U.S. NUCLEAR REGULATORY COMMISSION

Report No. 50-255/OLS-86-01

Facility Name: Palisades Nuclear Plant

Examination Summary

PALISADES TECHNICAL DATA BOOK FIGURE 5.1, REV 2  
 CYCLE 7  
 INTEGRAL ROD WORTH

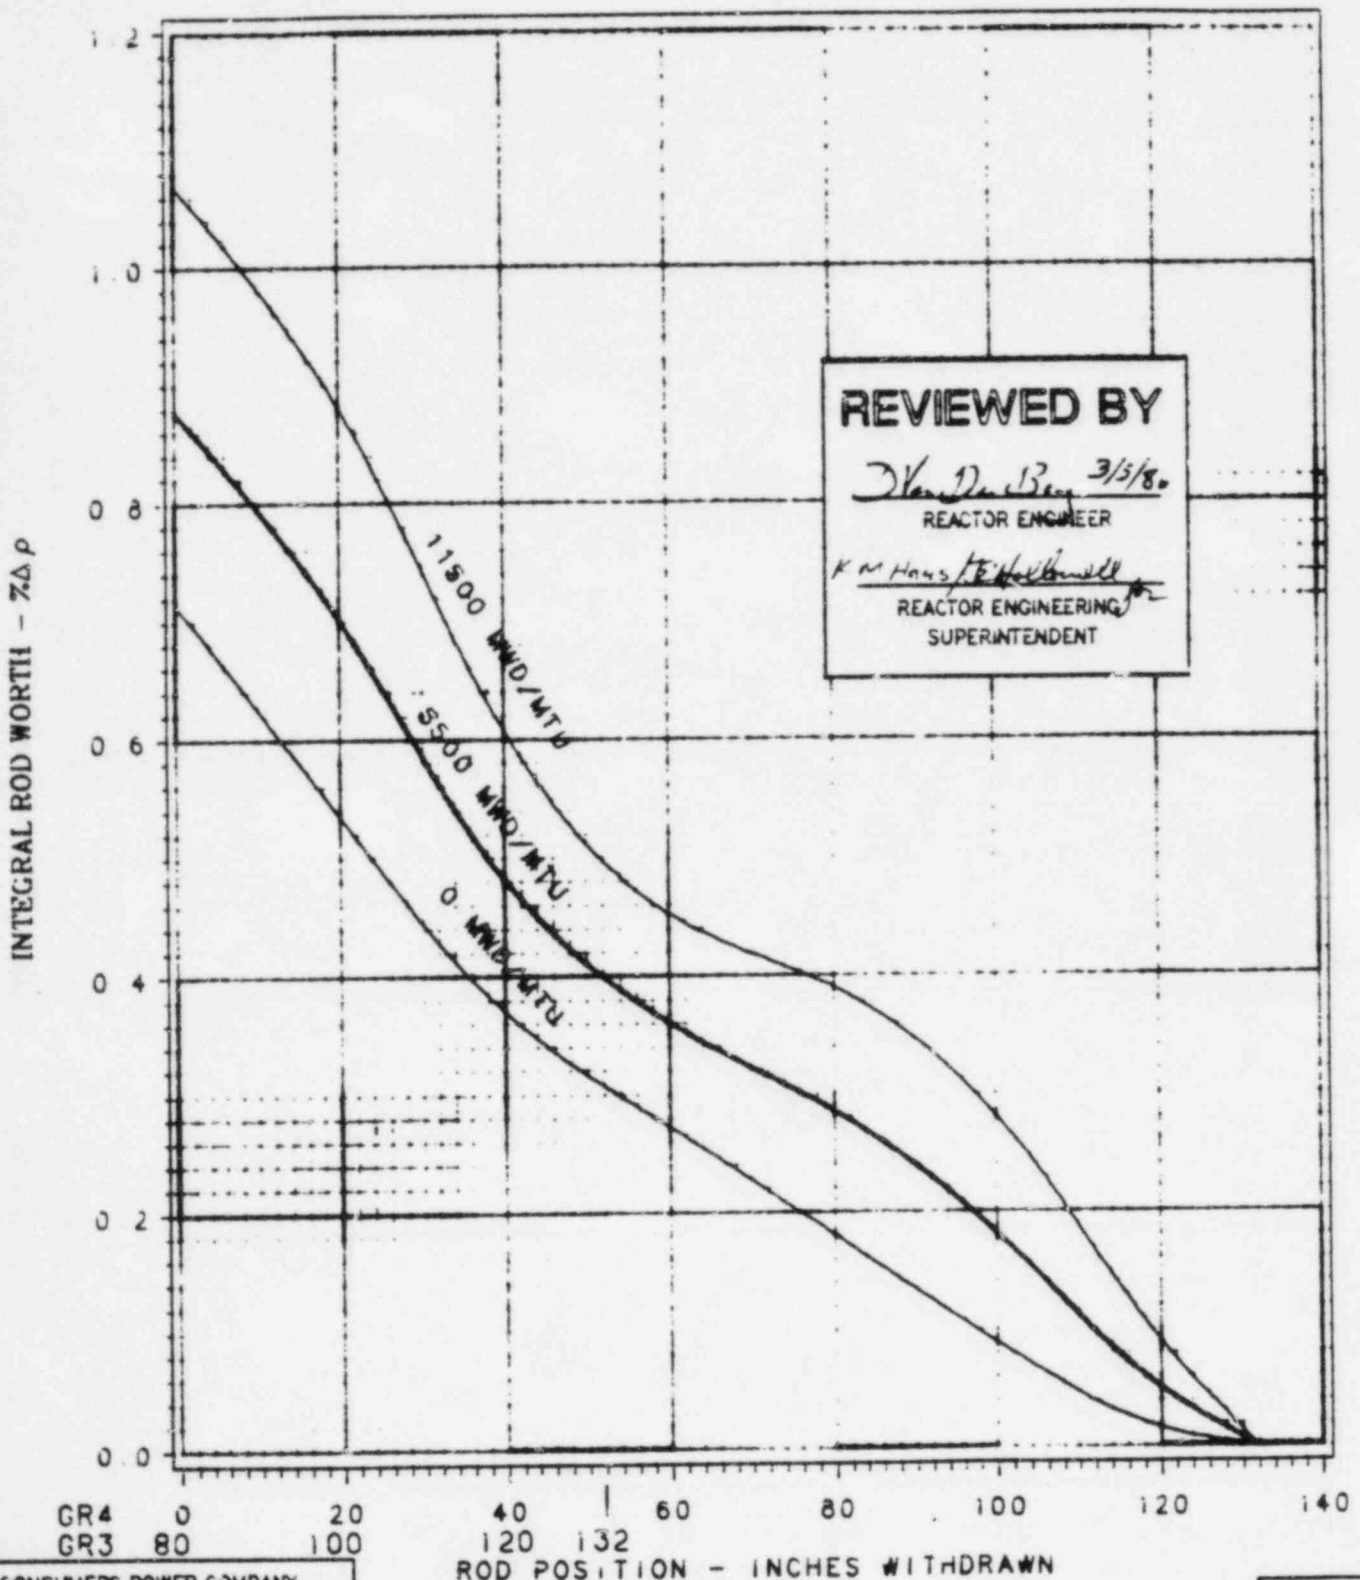
Facility Comment: There are several factors which change over core life to influence flux which thereby changes control rod worth. The answer key concentrates on only one of those factors. Additional acceptable factors are suggested.

Recommendation: Allow the following as an additional acceptable answer: "Neutron flux increases over the life of the core due to several factors (reduction in boron concentration, depletion of burnable poisons, fuel depletion necessitating an increase in flux to maintain a constant fission rate, etc.). This increase in flux results in a larger control rod worth since rod worth is proportional to neutron flux (thermal and epithermal)."

NRC Response: Agree. The answer key was modified to also grant credit for the following responses: (1) "increase thermal neutron flux at EOL;" and (2) "depletion of burnable poisons and the reduction in boron reduces the competition for neutrons, causing the rods to be exposed to a greater neutron flux."

Mollier diagram (h-s) for steam.

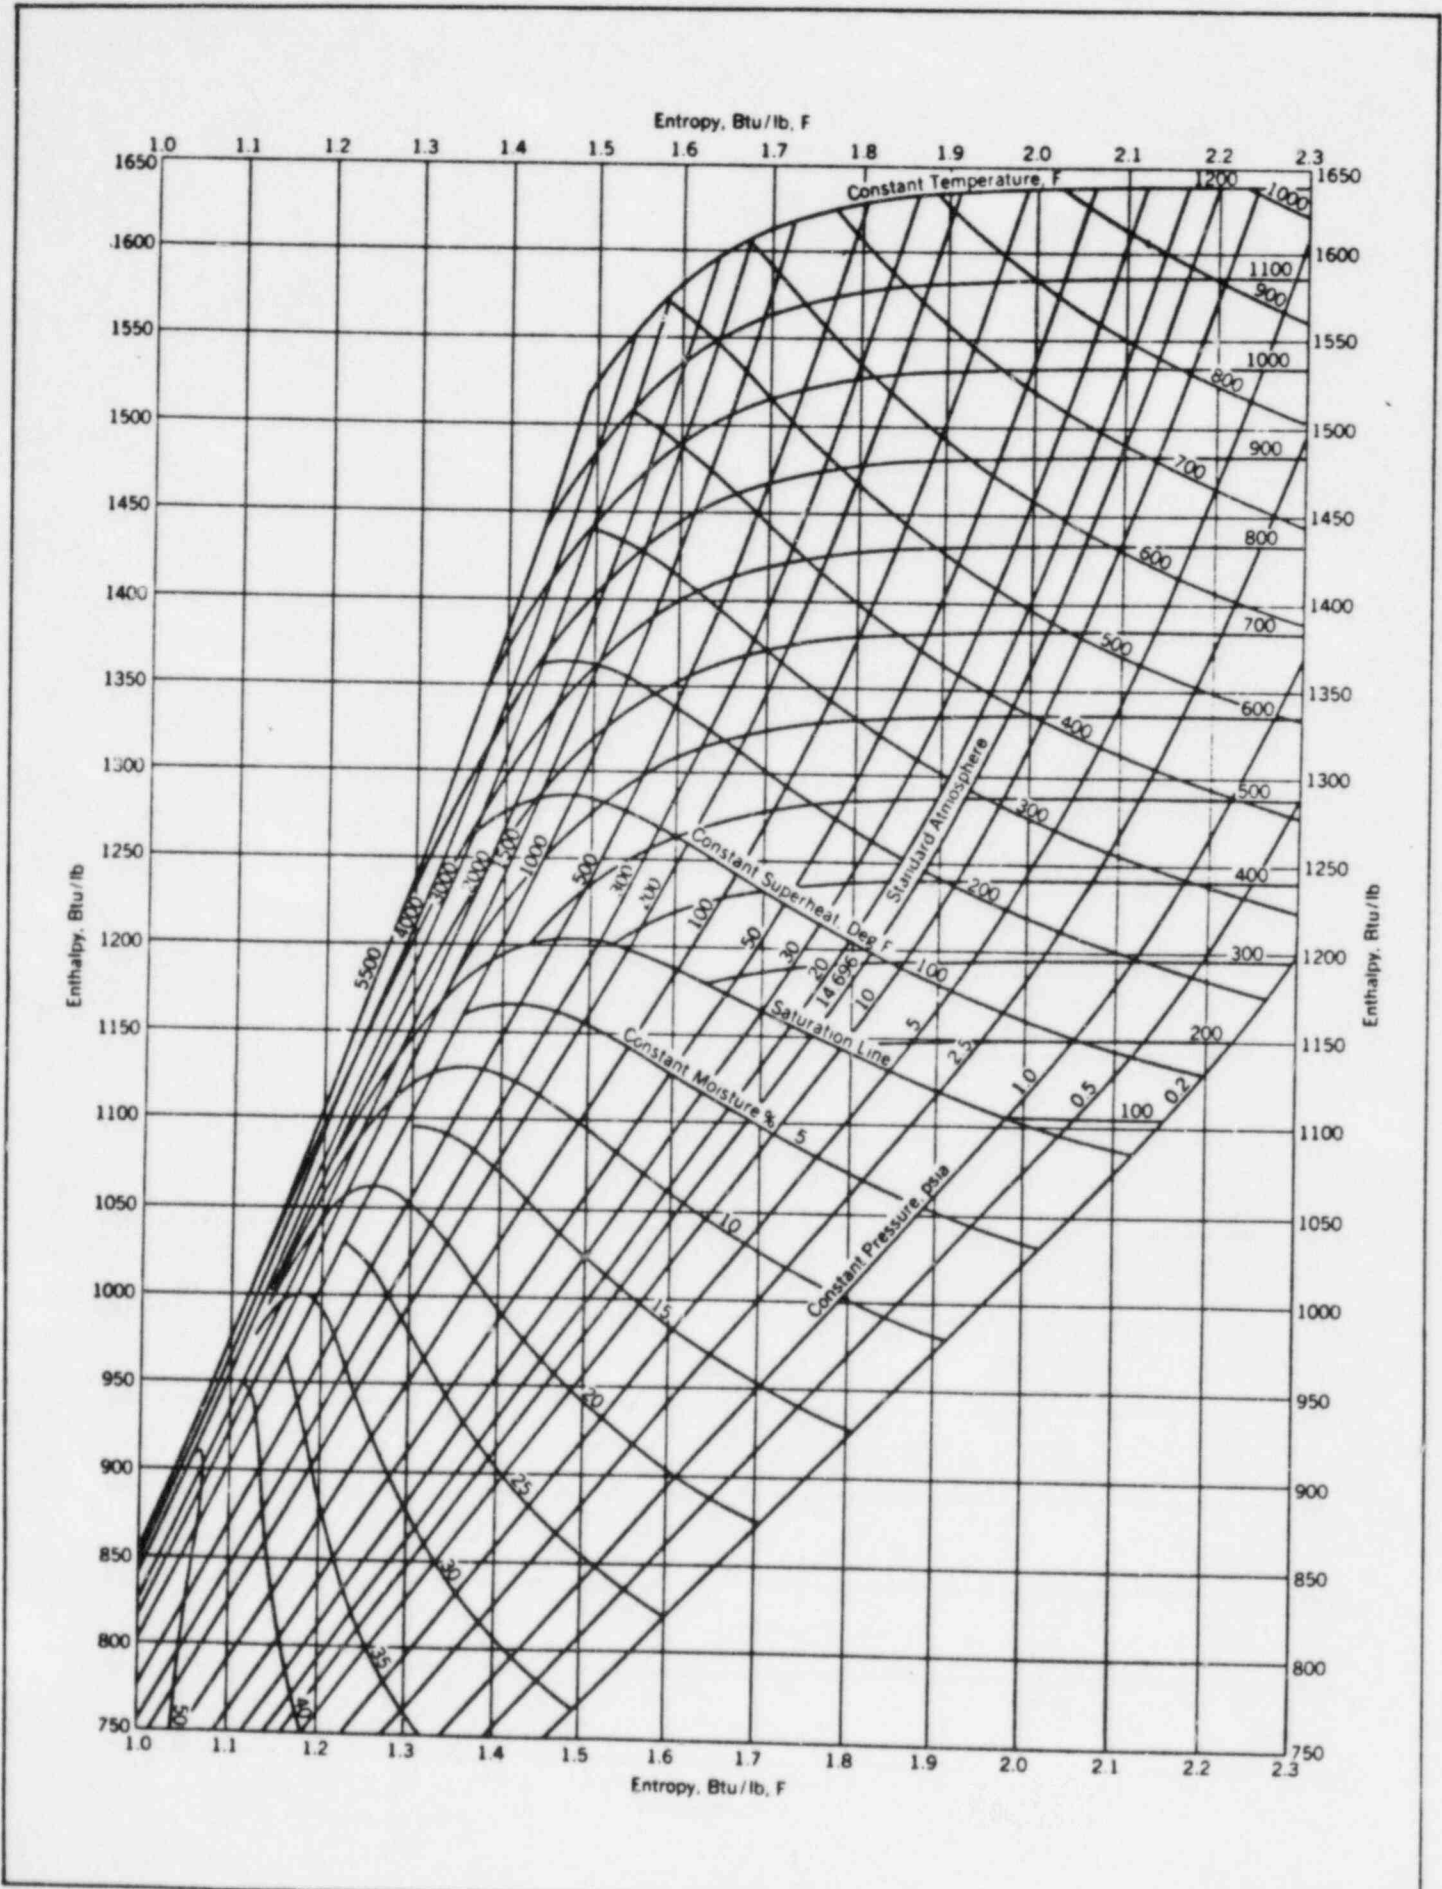
Facility Comment: If the candidate uses only the Mollier diagram provided and follows constant enthalpy from interpolated points for 1715 psia/715 psia to 35 psia, he has to again interpolate between hundred degree lines which are one-half inch apart. Therefore, the allowable temperature band for an acceptable answer should be expanded.

NRC Response: Disagree. The answer key was not changed.
